RE: JOB NO. 14046
TOWN OF TRUMBULL
MARY J. SCHERLACH COUNSELING CENTER
RENOVATIONS & ALTERATIONS
121 OLD MINE ROAD, TRUMBULL, CT

SUBJECT: ADDENDUM NO. 1

DATE: OCTOBER 20, 2014

E-3

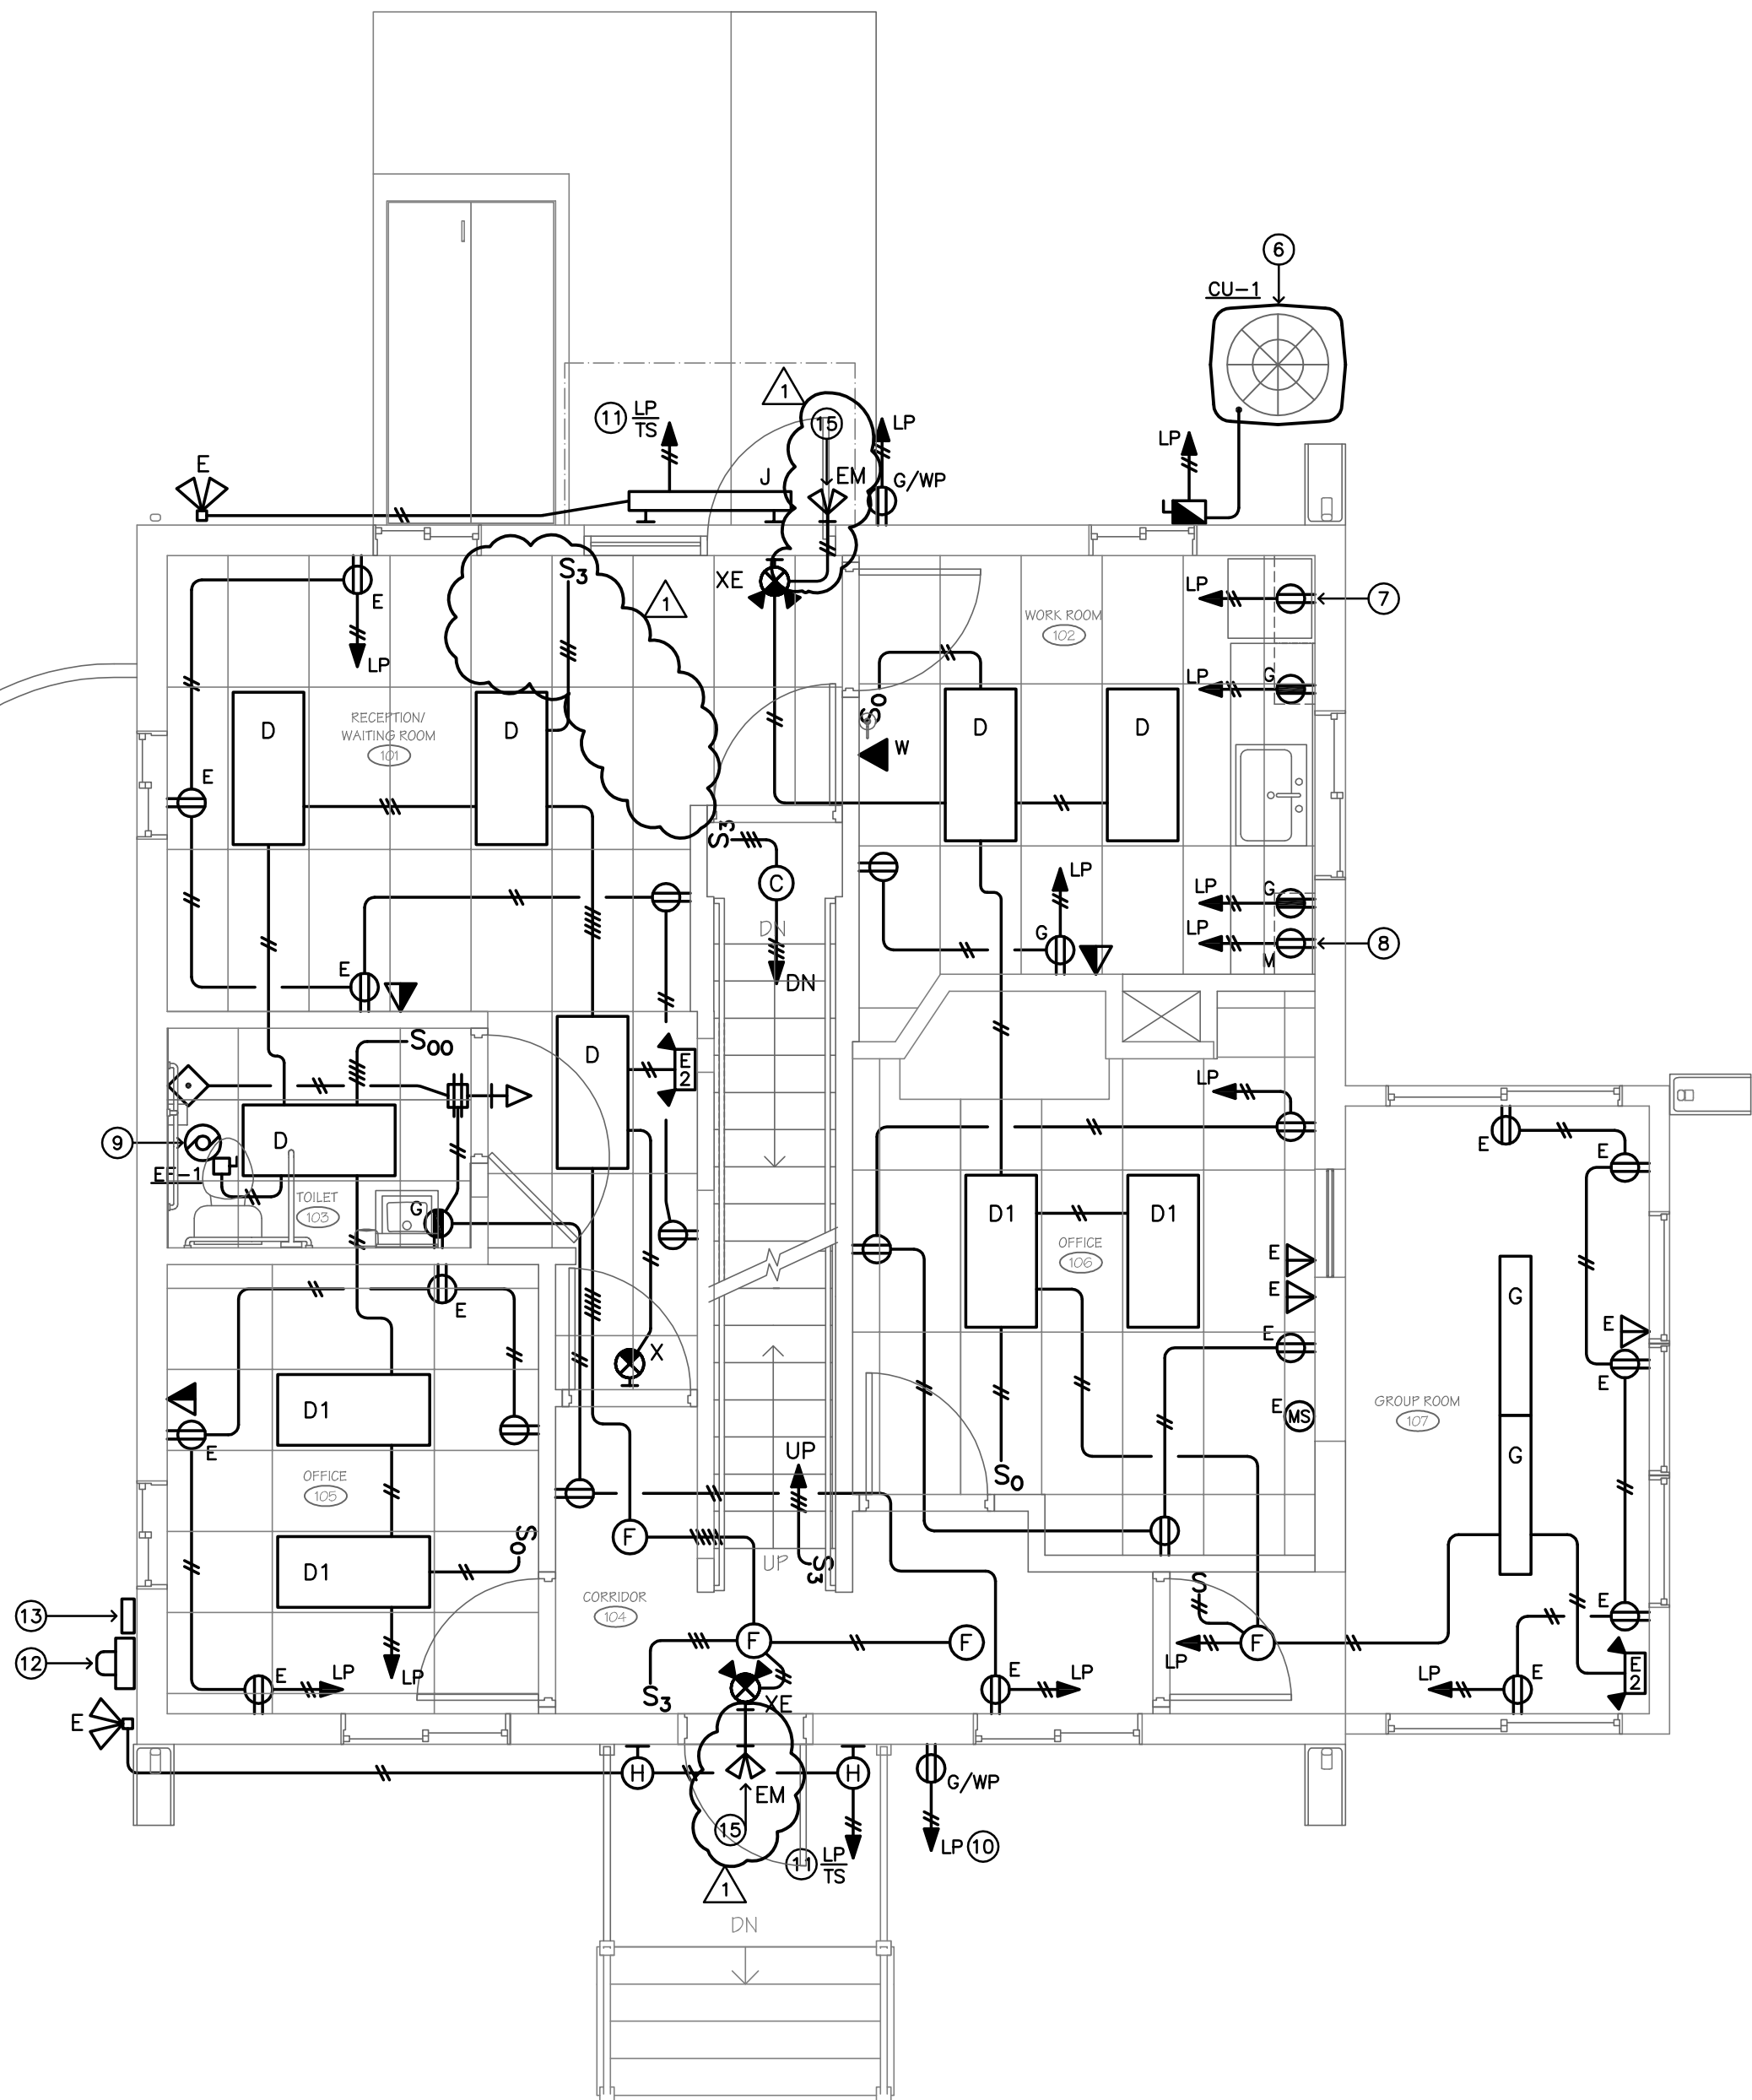
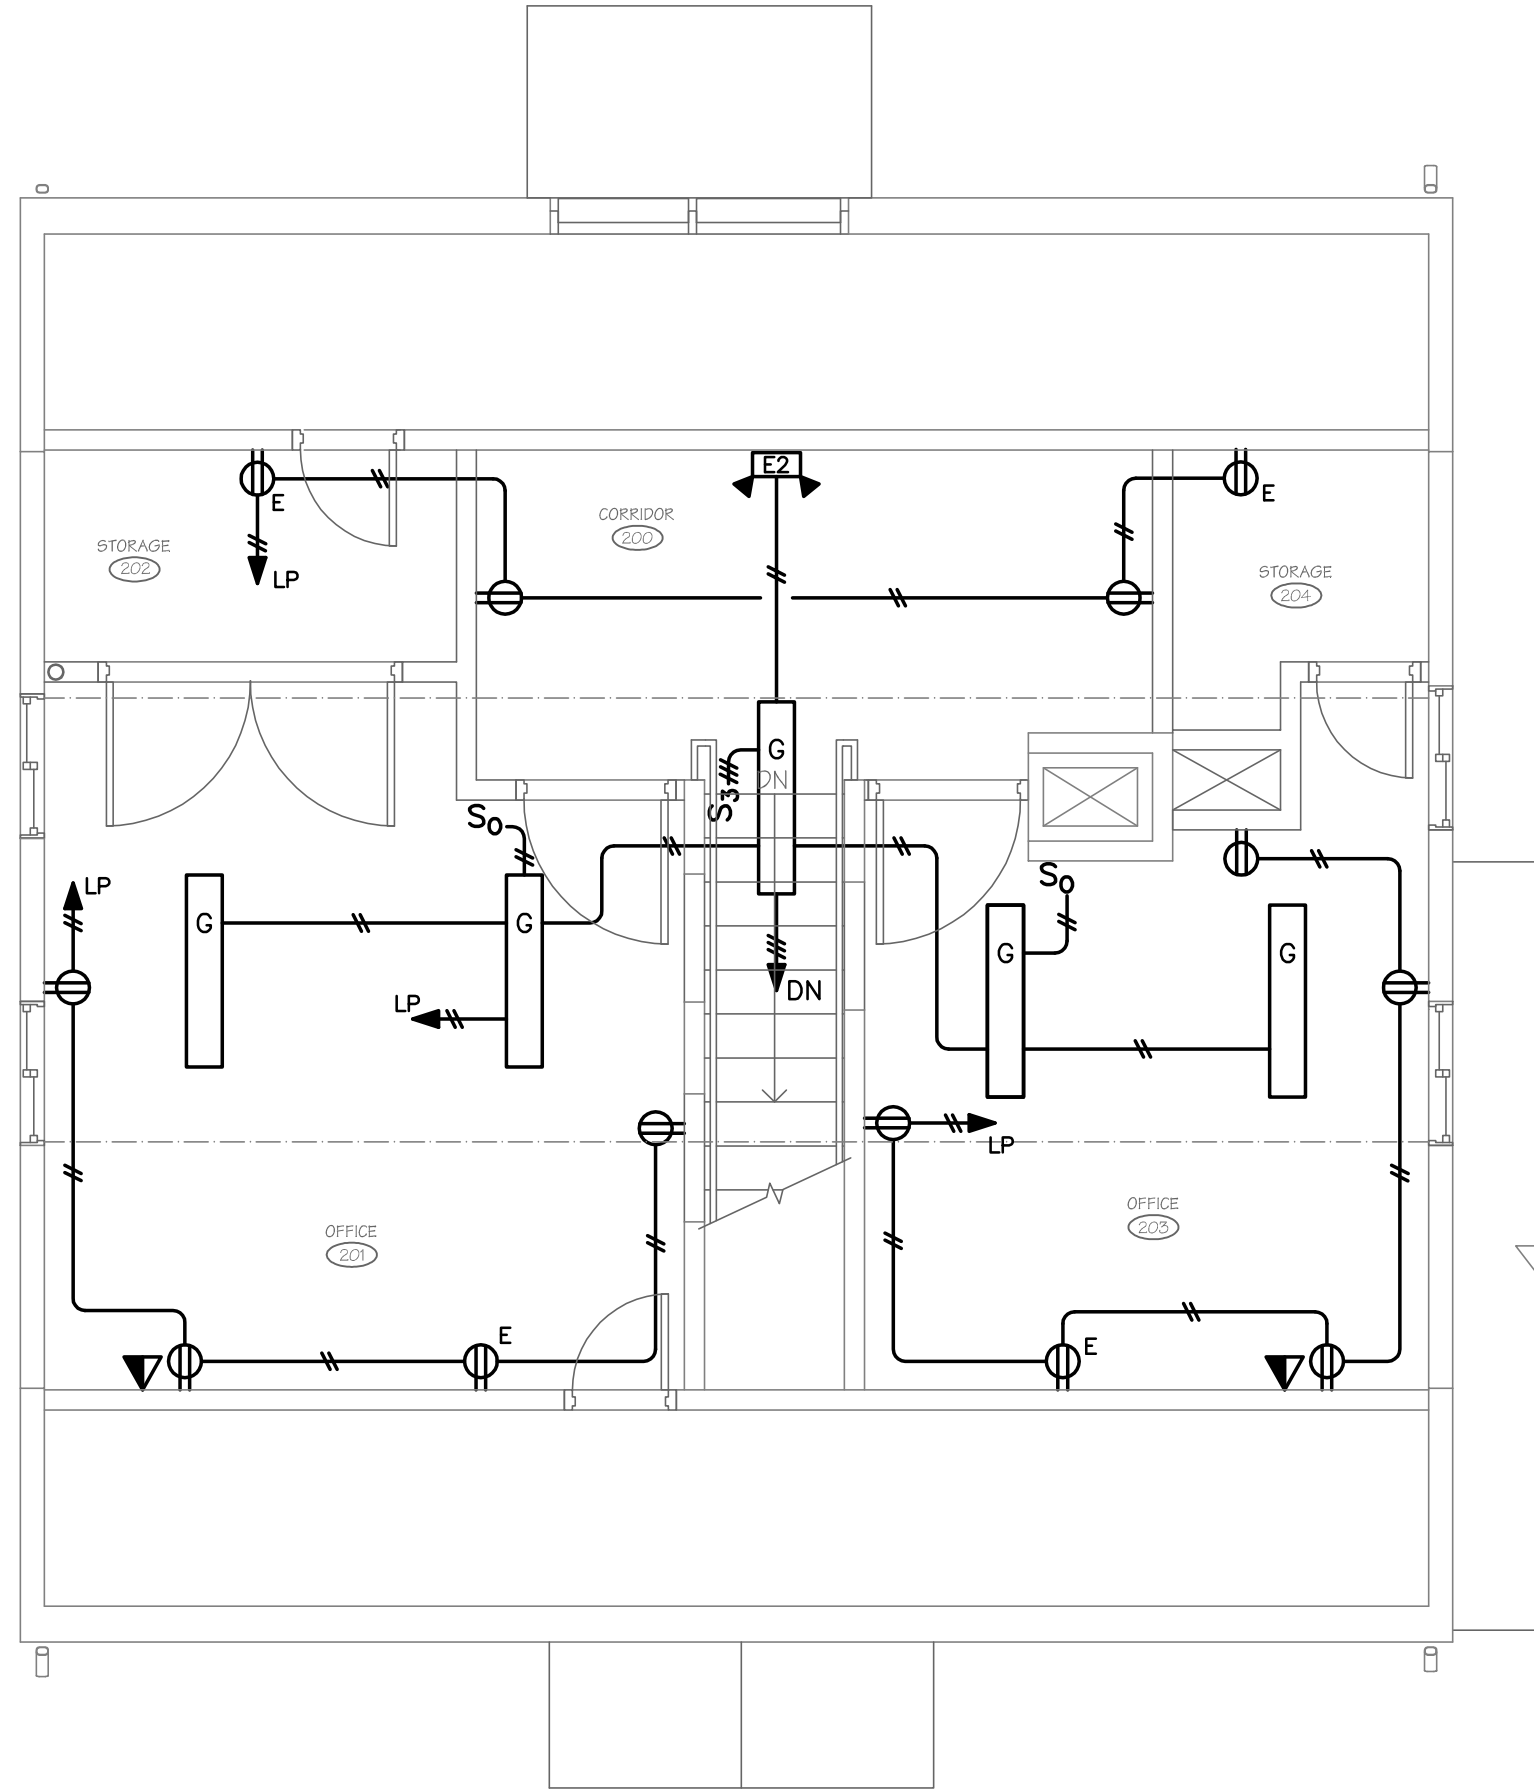
3. DRAWINGS – E-1, E-3, E-4

- A. Refer to three (3) attached revised drawings dated Revision #1 – 10-20-14.
